Contract #: 04-0120F4Cty: SF/ALA Rte: 80 PM: 13.2/13.9File #: 69.25B**QUALITY ASSURANCE -- NON-CONFORMANCE REPORT****Location:** Changxing Island, Shanghai, P.R. China**Report No:** NCR-000237**Prime Contractor:** American Bridge/Fluor Enterprises, a JV**Date:** 28-Mar-2009**Submitting Contractor:** Zhenhua Port Machinery Company, Ltd (ZPMC), Changxing Island**NCR #:** ZPMC-0211**Type of problem:**

**Job Name:** SAS Superstructure

**Subject:** NCR No. ZPMC-0211

**Reference Description:** A Class "A" indication was not found by QC UT Technician

WELD NUMBER: CB202D-001-001

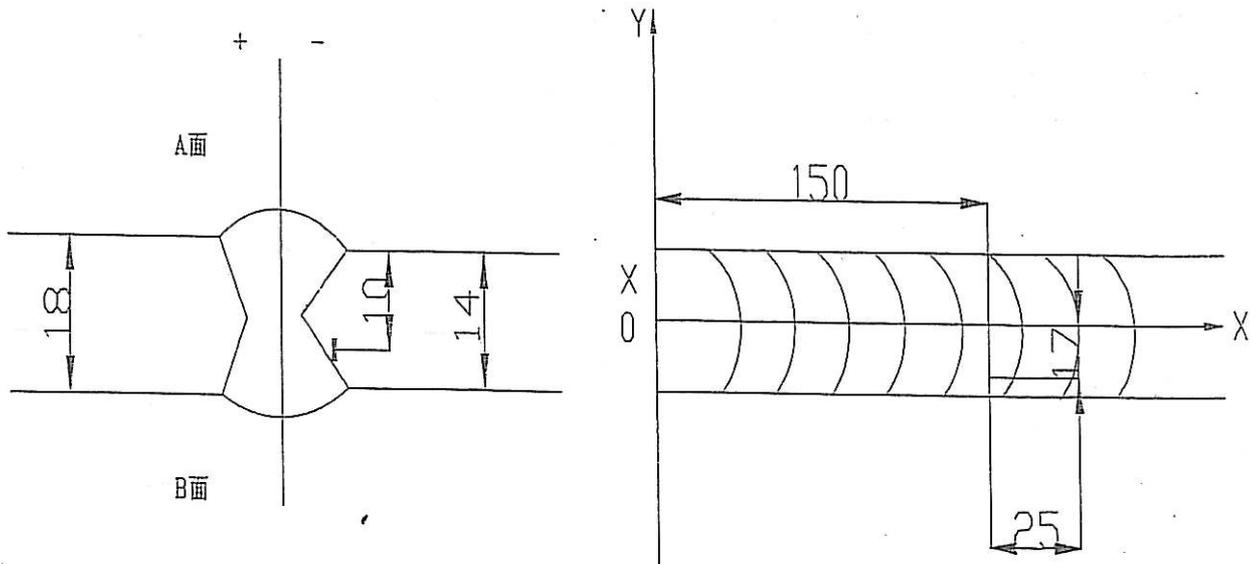
焊缝缺陷描述:

Rejected indication found by ultrasonic inspection is less than the maximum allowance aggregate length.

(UT探伤发现的缺陷总长度小于最大允许长度。) CB202D-001-001

1. 从缺陷距离端面较近一侧 ( $D \leq 0.65T$ , D为缺陷深度, T为板厚) 采用碳刨或打磨的方法去除焊缝缺陷;
2. 参照返修焊接工艺规程 (WPS) 准备正确的接头型式, 预热和焊接;
3. 焊前对修补区域进行VT检测保证缺陷完全被清除;
4. 将修补区域打磨到与母材或邻近焊缝平齐;
5. 根据批准的车间图纸检查焊缝.

1. Gouge or grind from nearer side from metal edge ( $D \leq 0.65T$ , "D" is depth of defects, "T" is thickness of metal) to remove all defects;
2. Follow repair WPS for joint preparation, preheat, and weld deposit;
3. Verify with VT no defects remain in the weld joint prior to welding;
4. Grind the repaired area flush with base metal or the adjacent weld;
5. Check the welds according to the working drawings.
